STATE OF HAWAII
DEPARTMENT OF TRANSPORTATION
HARBORS

ADDENDUM NO. 1

**FENDER REPAIRS AT PIER 3,
HILO HARBOR, HAWAII**

JOB S50208

EYENUT ASSEMBLY DETAIL

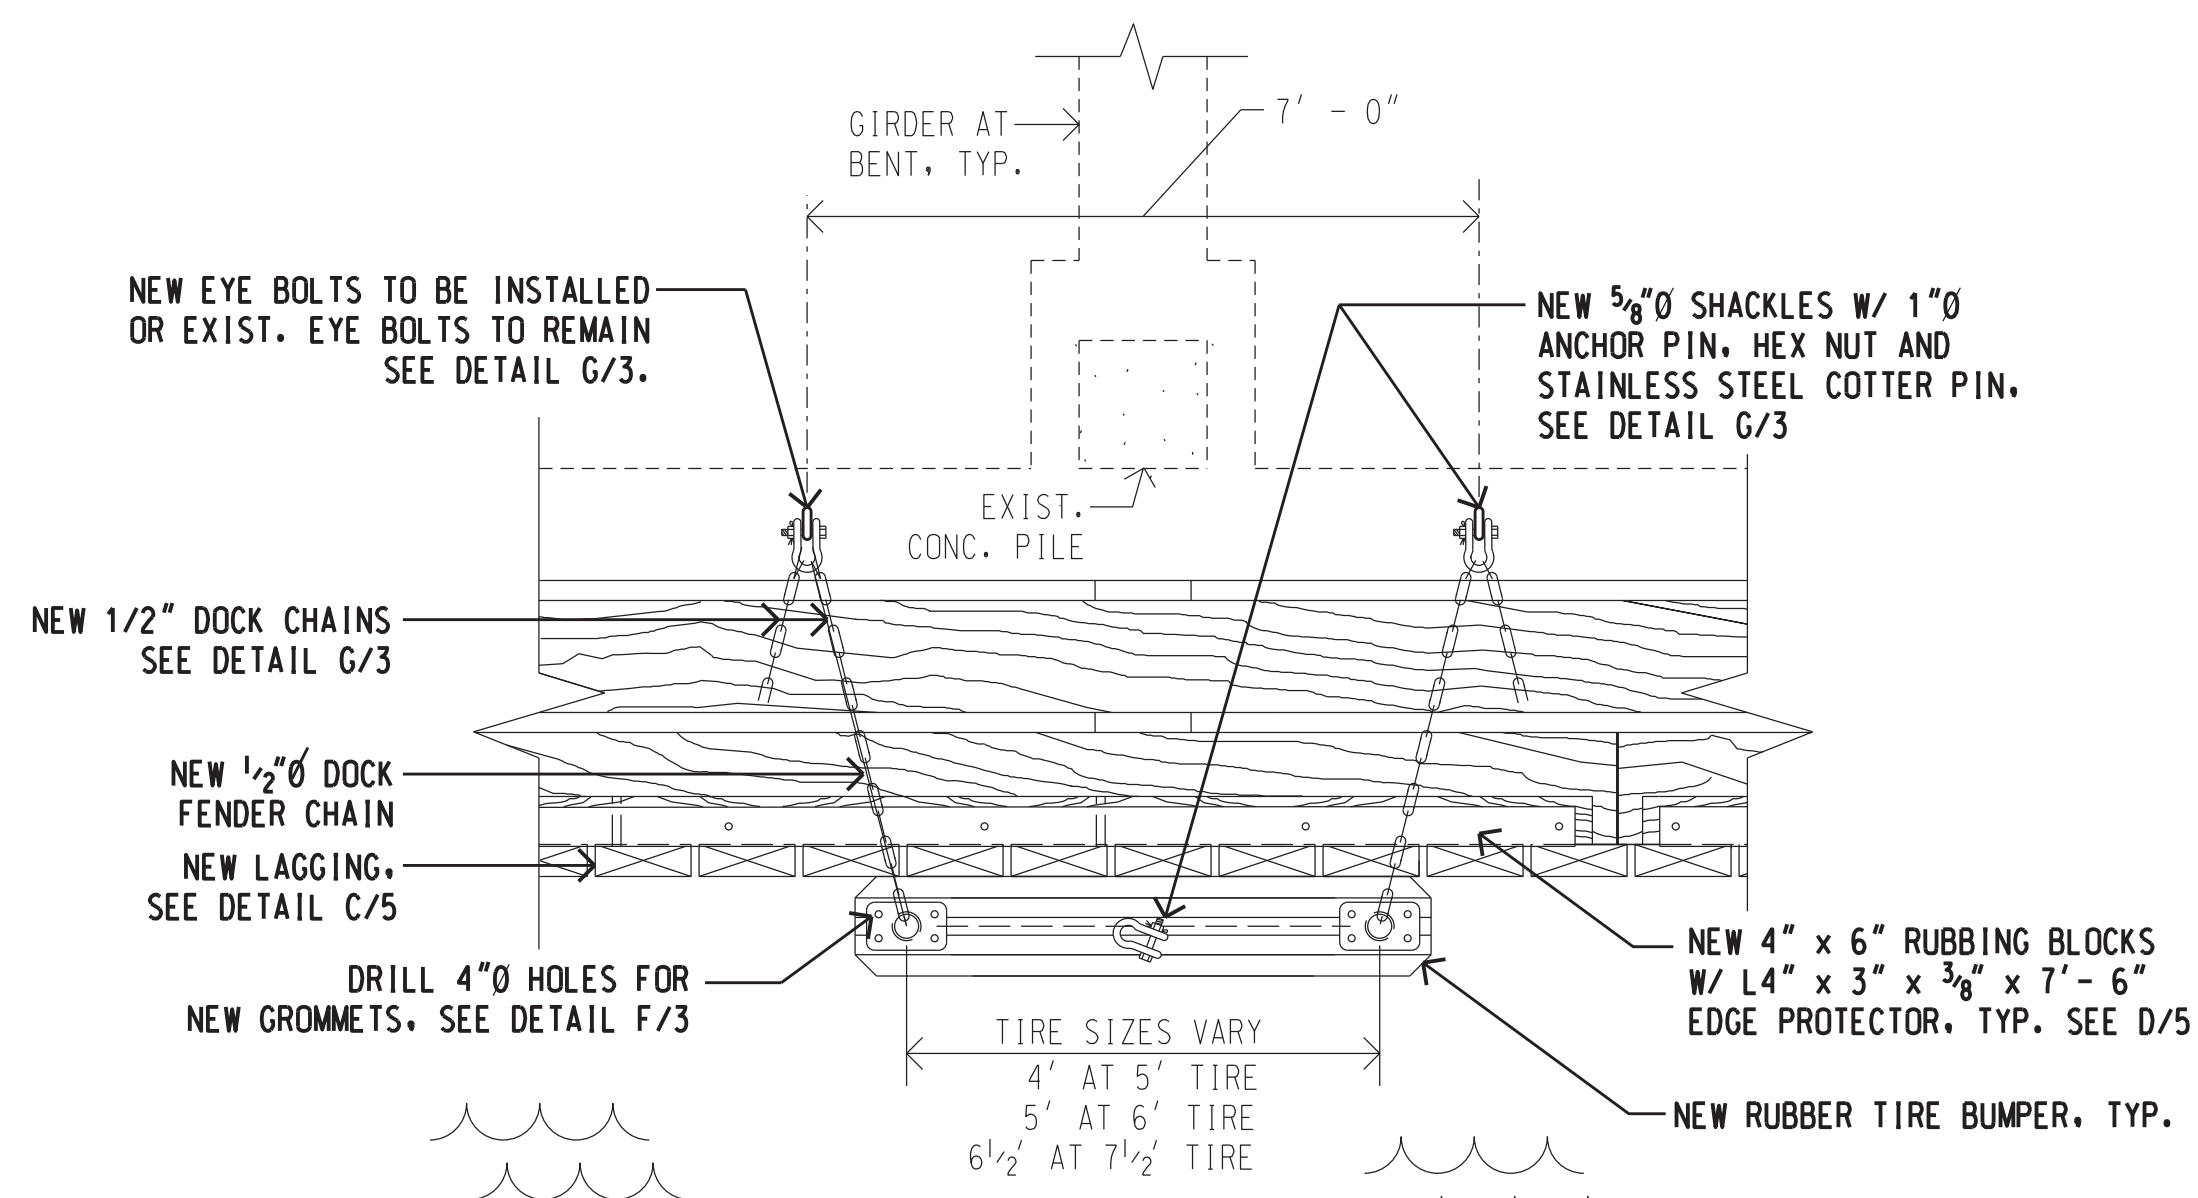
REVISED EYENUT ASSEMBLY DETAIL G/3

NEW TIRE BUMPER ASSEMBLY DETAIL AT EYE-BOLTS

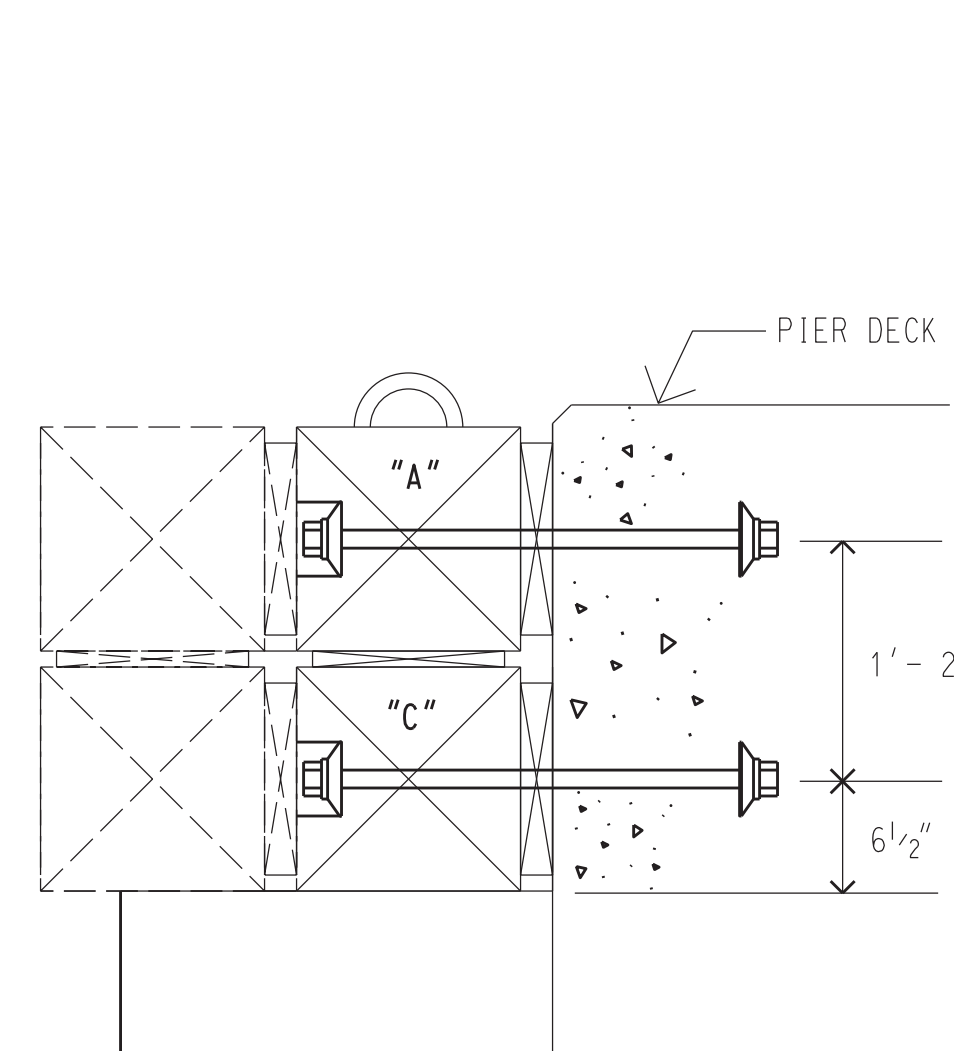
REVISED NEW TIRE BUMPER ASSEMBLY DETAIL AT EYE-BOLTS DETAIL C/3

TYPE "I" BOLTS

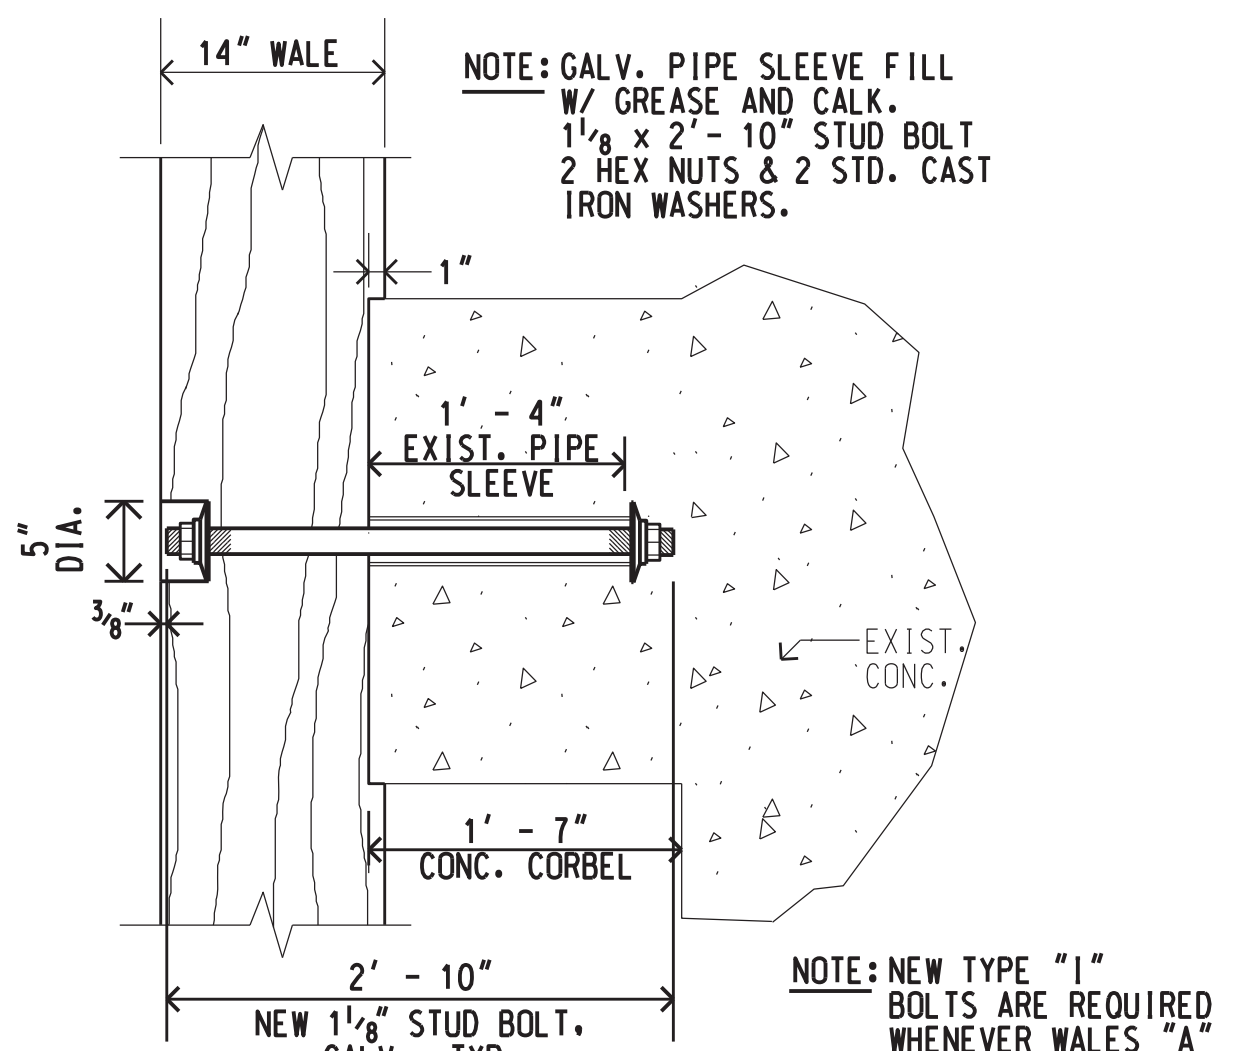
NEW TYPE "I" BOLTS DETAIL H/3
